# MODIFICATION INSTRUCTIONS

## ***KODAK X-Omatic* MULTILOADER 700**

### MODIFICATION No. 22

PURPOSE:

figure 2

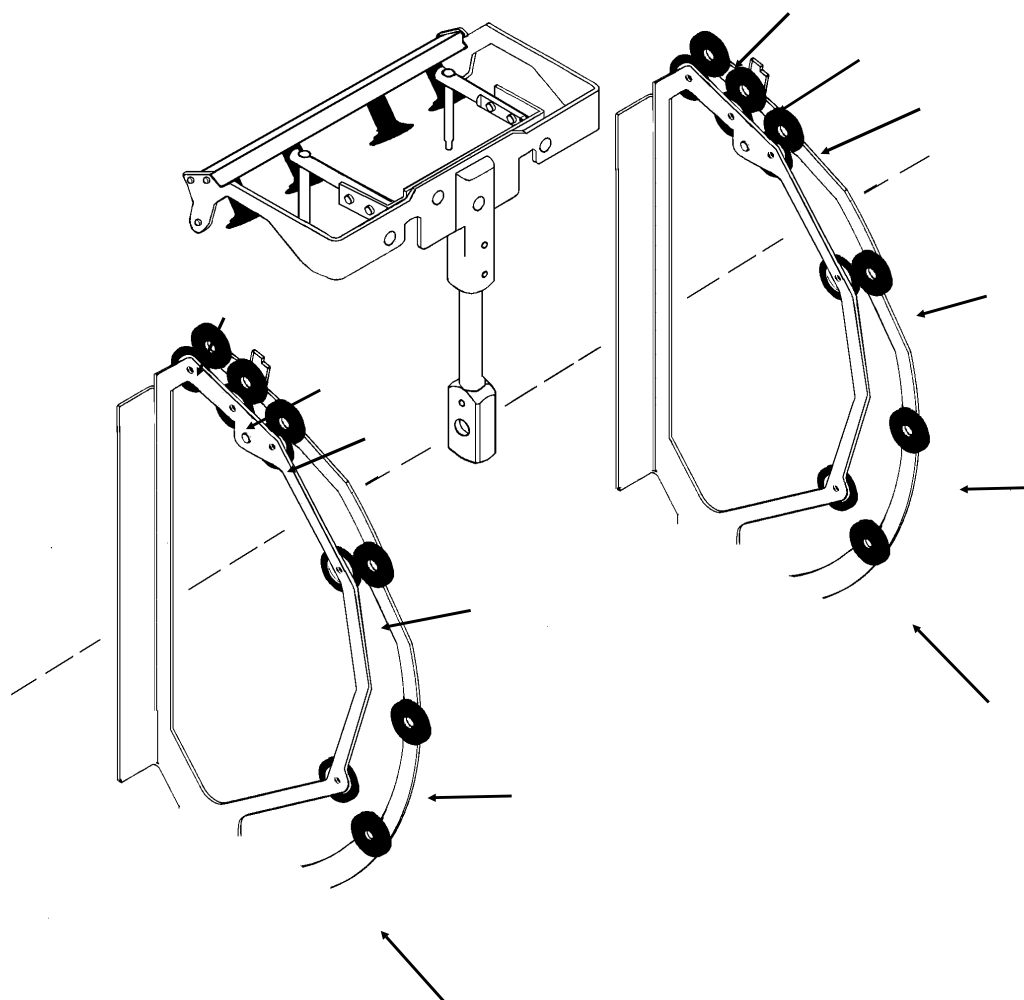
1. Switch off the ML700.
2. Take off the REAR PANEL.
3. Replace the outer FOAM ROLLERS of the FILM POCKET with O-RINGS. Use 1 O-Ring for each ROLLER. See figure 2.

Replace the outer FOAM ROLLERS (marked with an arrow) with O-RINGS. Use 1 O-RING for each ROLLER.

figure 3

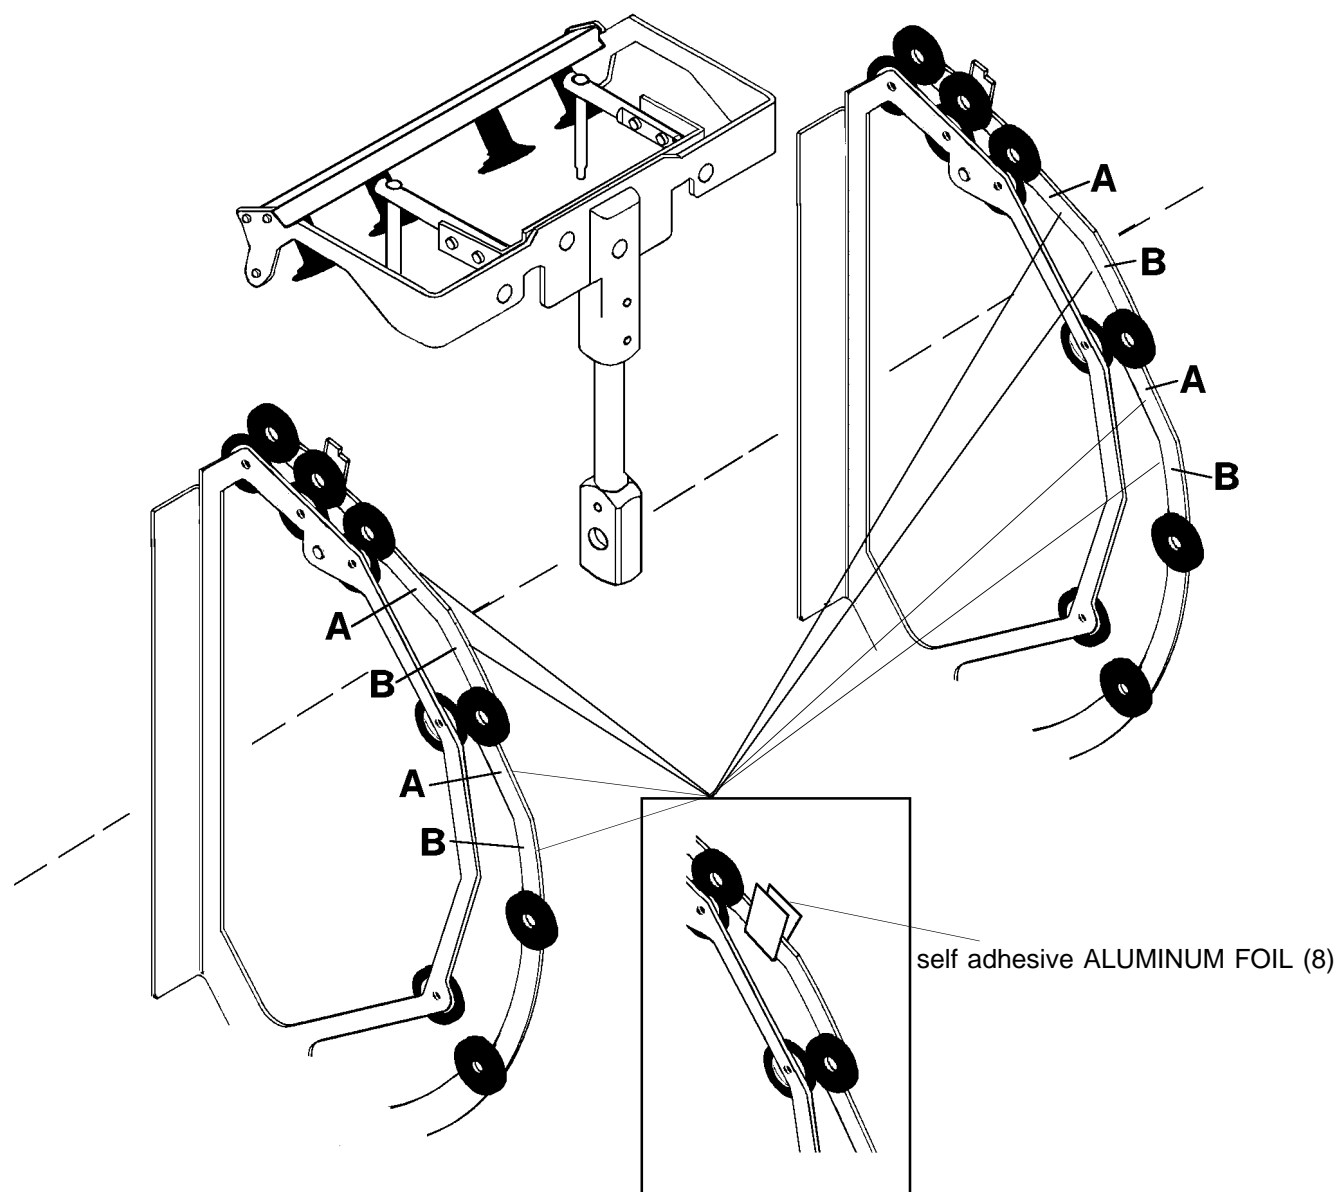
4. Fold the 8 self adhesive ALUMINUM FOILS ( EDGE PROTECTORS) and mount them from underneath to the outer BRACKETS of the FILM POCKET. This prevents the FILMS from becoming abraded by the sharp edges of the FILM POCKET BRACKETS. Mount the FOILS in position A first. Then mount the FOILS in positions B so that they overlap a little the FOILS in positions A. See figure 3.
